**RFI 098
Pebble Project EIS**

Title/Subject:	TSF Options, Mine Area
Requestor:	AECOM
Date Transmitted:	10/16/2018
Recipient:	Pebble Limited Partnership (PLP)
Response Requested by:	10/22/2018
Rationale:	The PLP response for RFI 069 presented 26 potential TSF locations that were considered near the mine area. Details on feasibility and environmental considerations for these locations are necessary for alternatives screening purposes and for the USACE to evaluate the Least Environmentally Damaging Practicable Alternative (LEPDA).
Describe the Information Requested and Level of Detail:	<p>Please provide an evaluation of each mine area TSF location that was considered and explain why the NFK West and NFK East locations were ultimately selected. Include:</p> <ul style="list-style-type: none"> • Feasibility (technology, economics, logistics, common sense) • Availability (both now and ten years ago during project planning) • Environmental impacts (wetlands/Waters of the US, miles of streams, habitat, fill, dam safety, etc.)

The question presented in RFI 098 on TSF options in the mine area is addressed below:

TSF OPTION 17

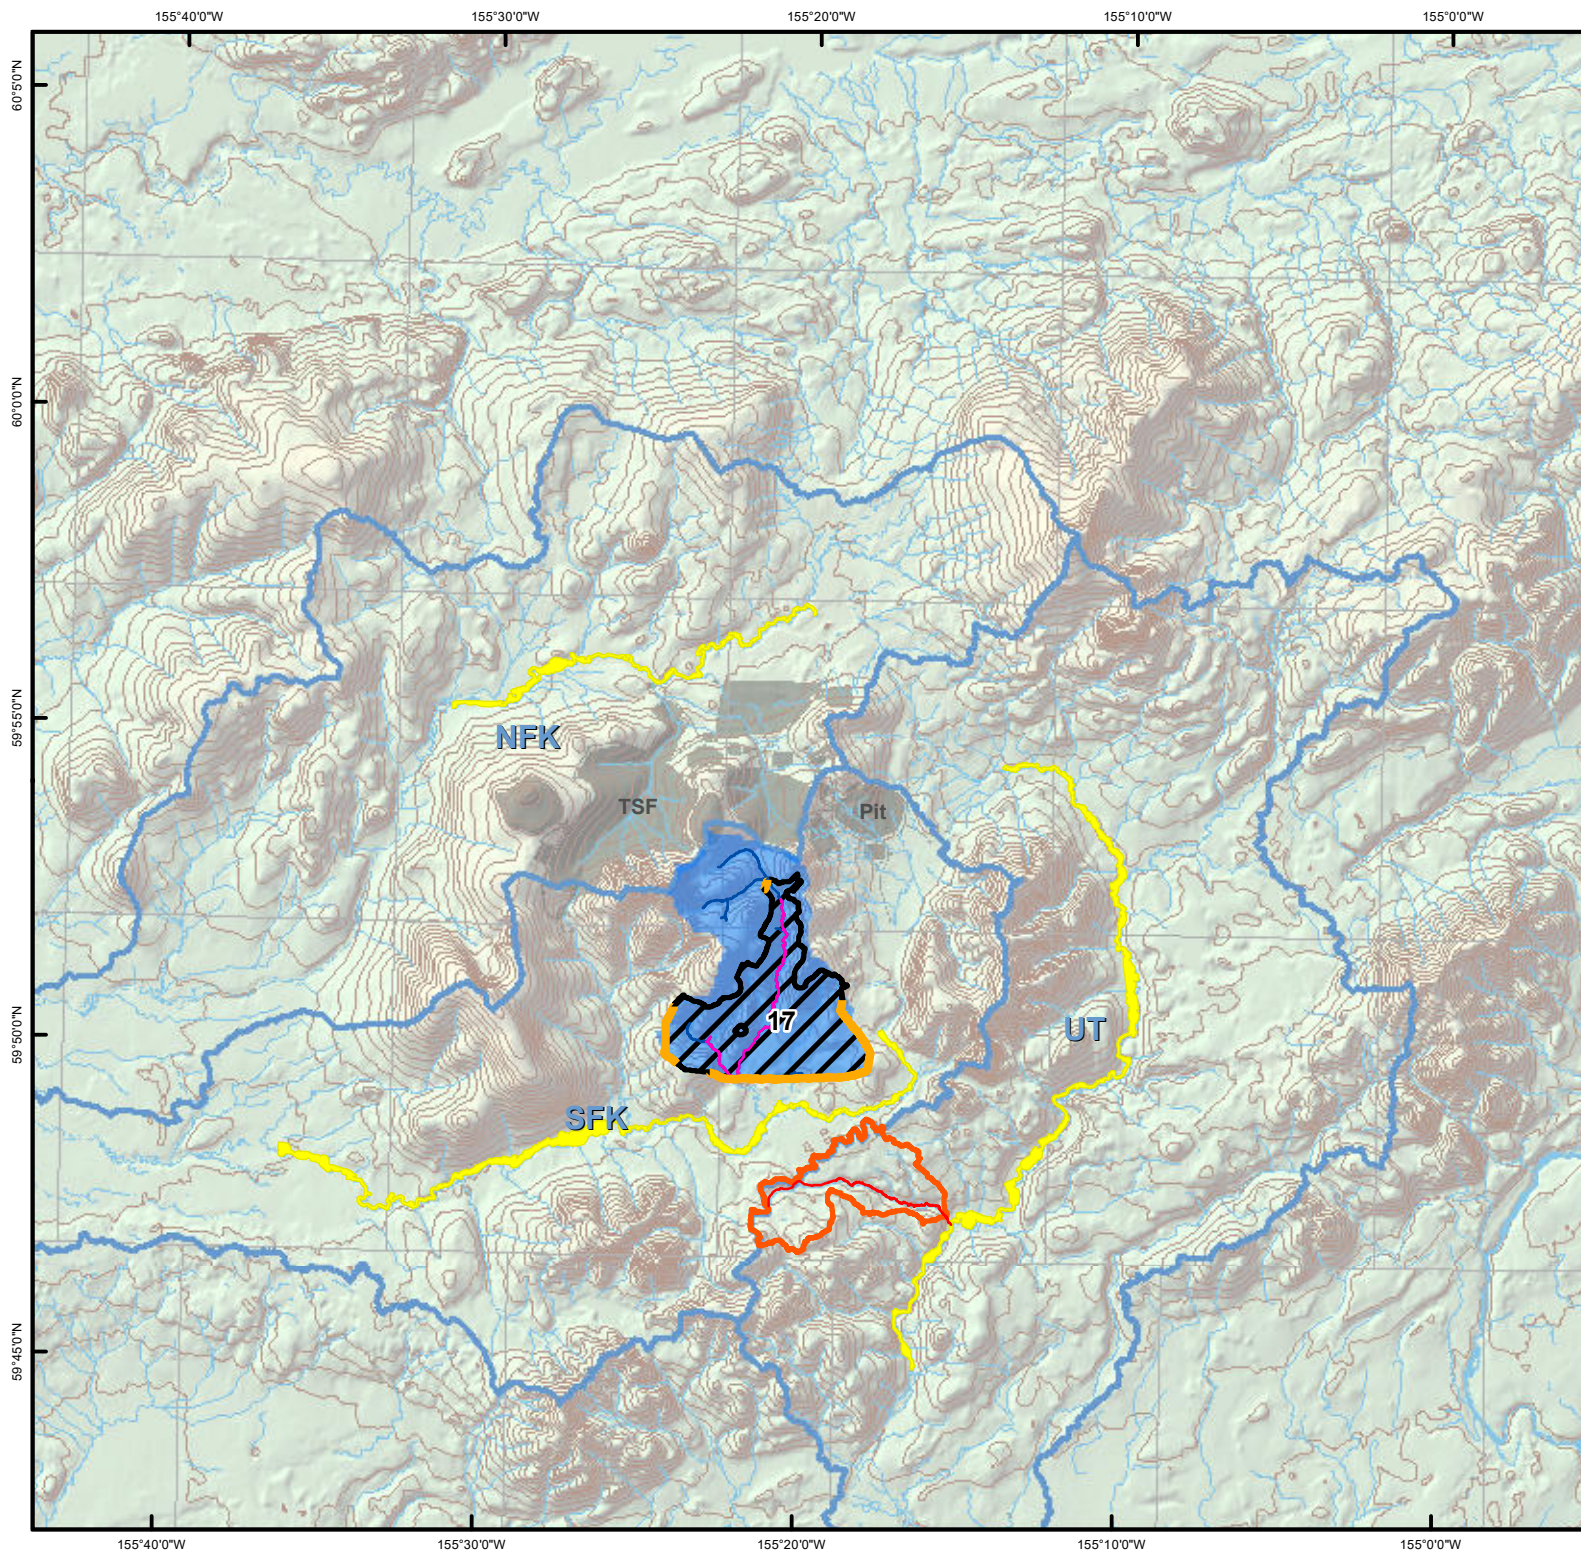
Option 17

- Has similar overall impacts in all the measured categories for footprint and stream miles, but with significantly lower wetlands acres filled.
- Embankment location precludes effective collection of seepage from a flow-through embankment and would have the potential to impact groundwater flows into the SFK and UTC 119A drainages.

TSF OPTION 18

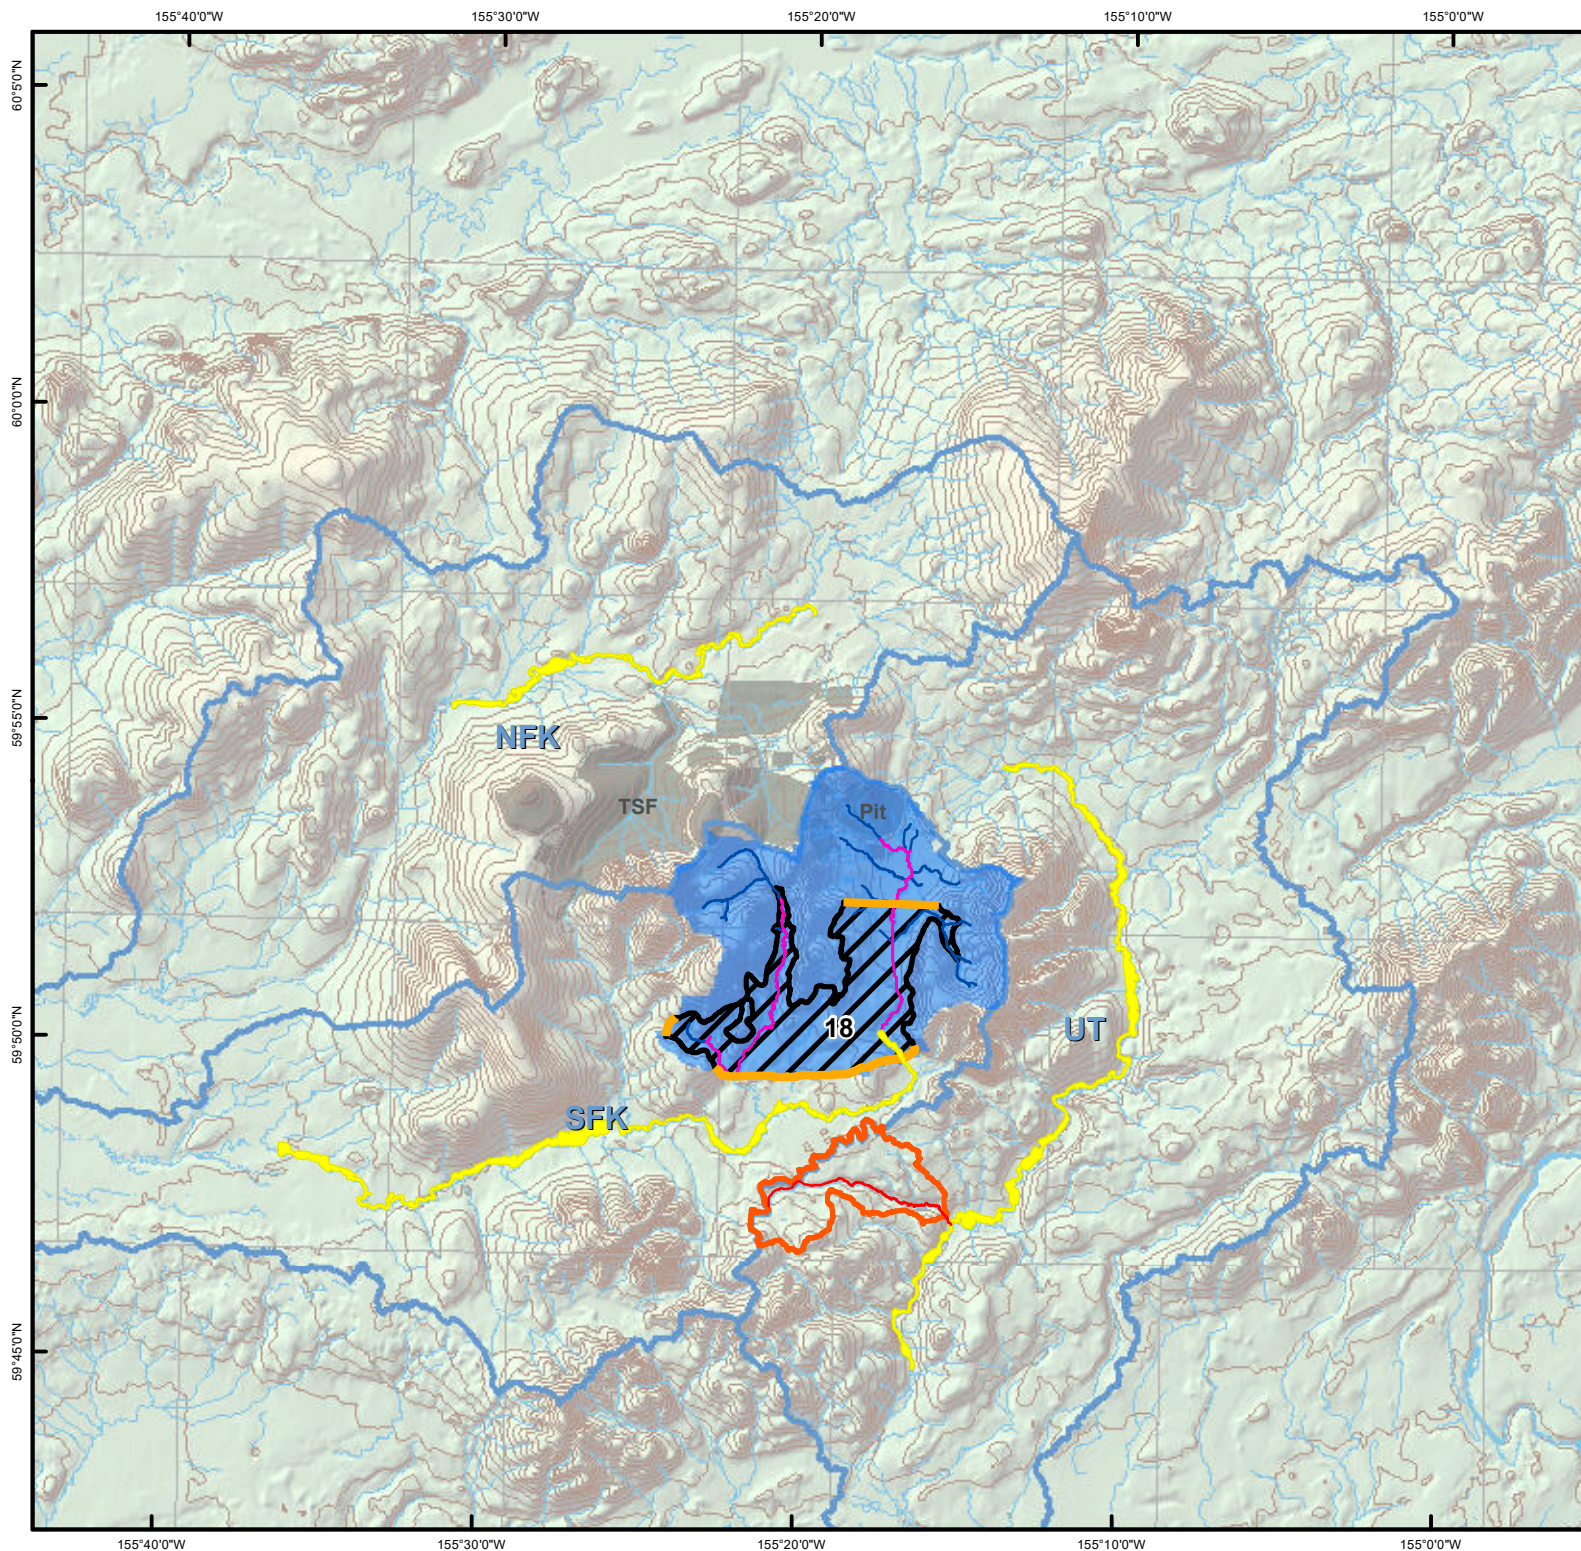
Option 18

- Fills less mapped wetlands but has a larger overall footprint and fills more stream miles.
- The impacted drainage basin and impacts to fish-bearing and anadromous streams are significantly higher.
- The footprint encroaches on MCO393.
- Embankment location precludes effective collection of seepage from a flow-through embankment and would have the potential to impact groundwater flows into the SFK and UTC 119A drainages.
- The facility as reported is larger than required to store 1250 million tons of tailings, but this would be adjusted by dropping the embankment height, which would not significantly change the reported impacts.

TSF OPTION 19

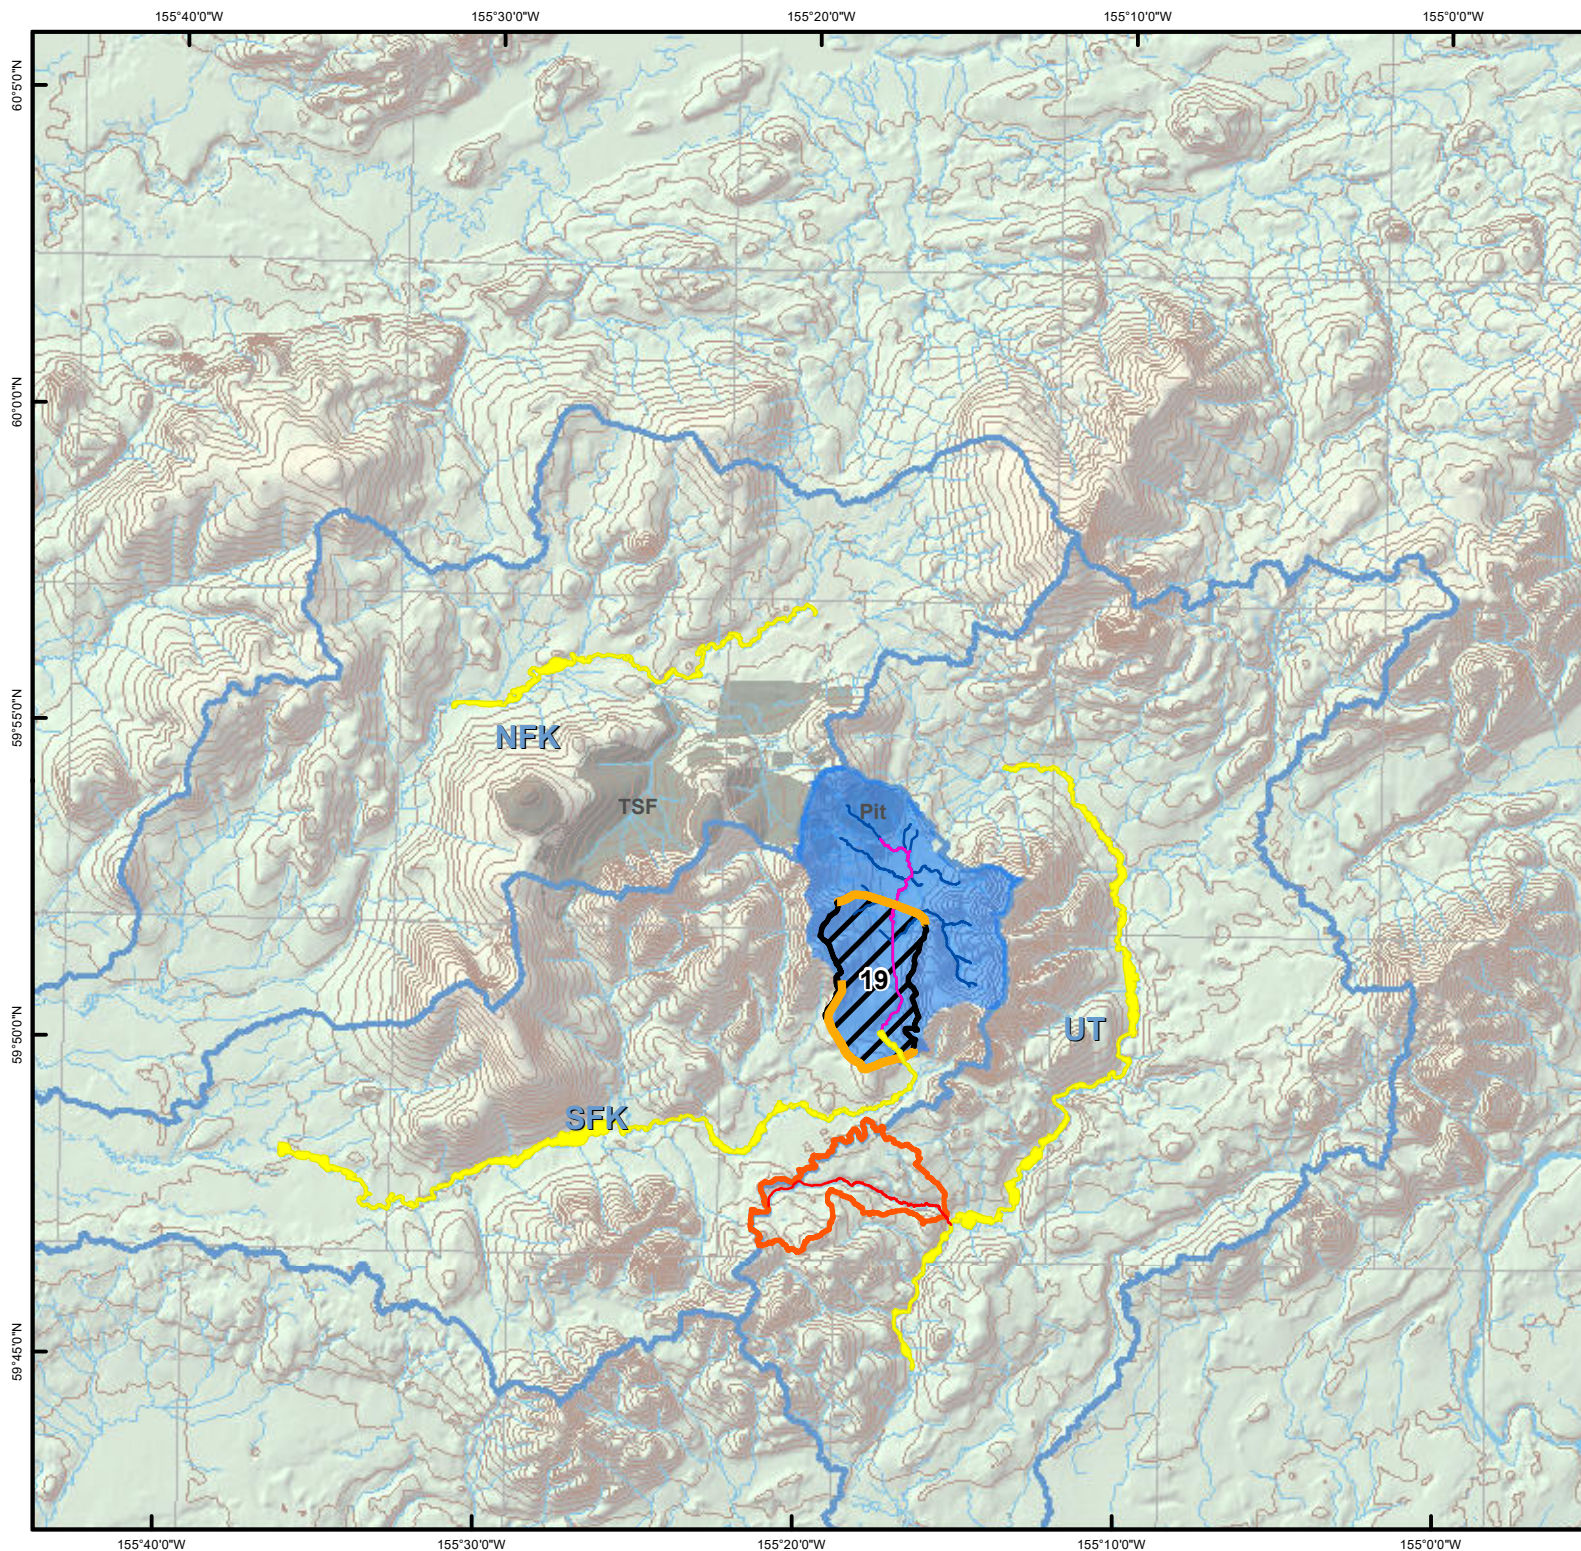
Option 19

- Has a smaller overall footprint and fills less mapped wetlands and stream miles, but impacts more fish bearing stream miles.
- Embankment location precludes effective collection of seepage from a flow-through embankment and would have the potential to impact groundwater flows into the SFK and UTC 119A drainages.
- The footprint encroaches on MCO393.

TSF OPTION 20

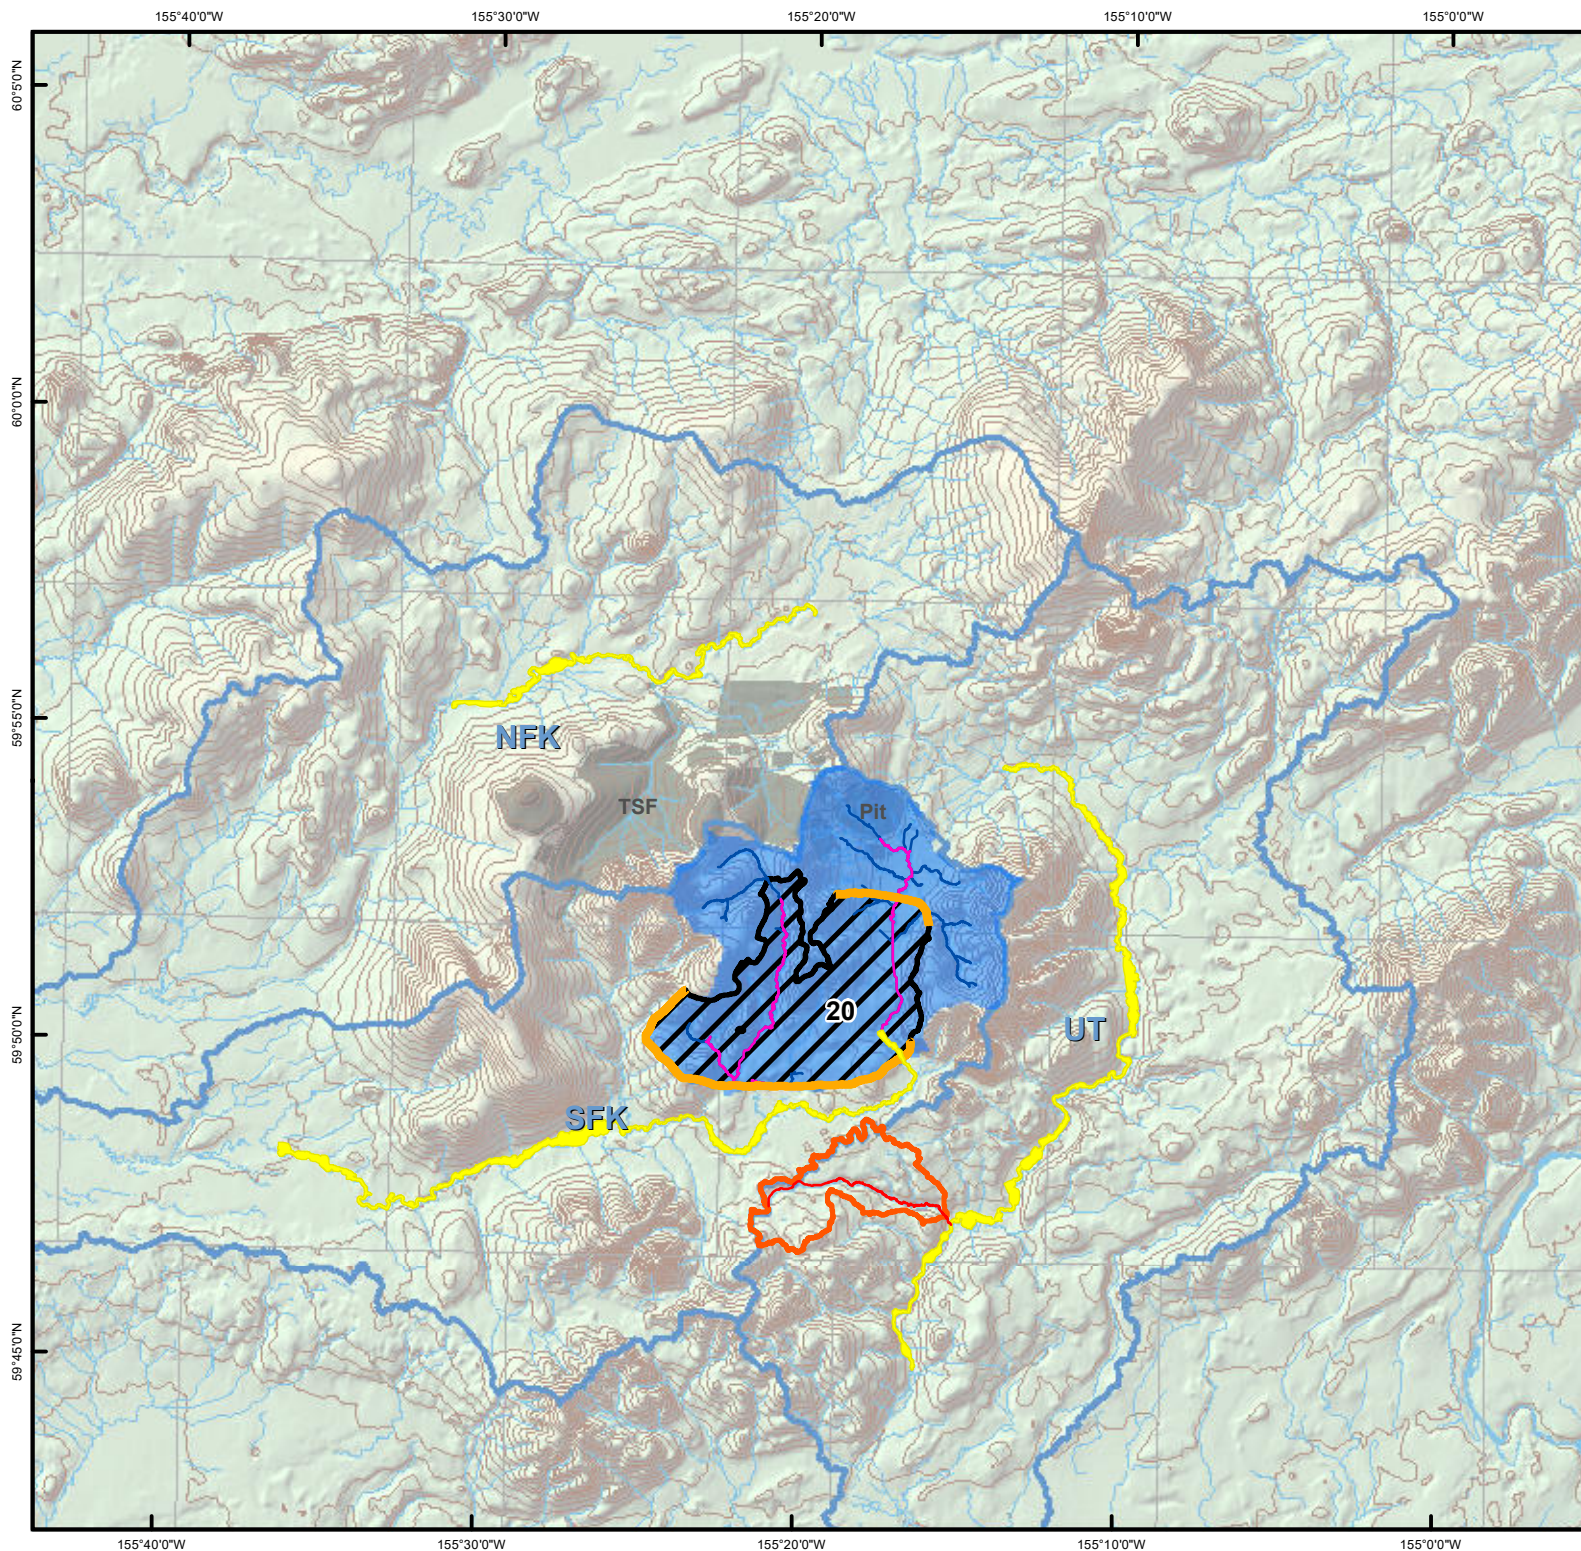
Option 20

- Fills less mapped wetlands but has a larger overall footprint and fills nearly two times as many stream miles.
- The impacted drainage basin and impacts to fish-bearing and anadromous streams are significantly higher.
- Embankment location precludes effective collection of seepage from a flow-through embankment and would have the potential to impact groundwater flows into the SFK and UTC 119A drainages.
- The footprint encroaches on MCO393.
- The facility as reported is larger than required to store 1250 million tons of tailings, but this could be adjusted by dropping the embankment height, which would not significantly change the reported impacts.
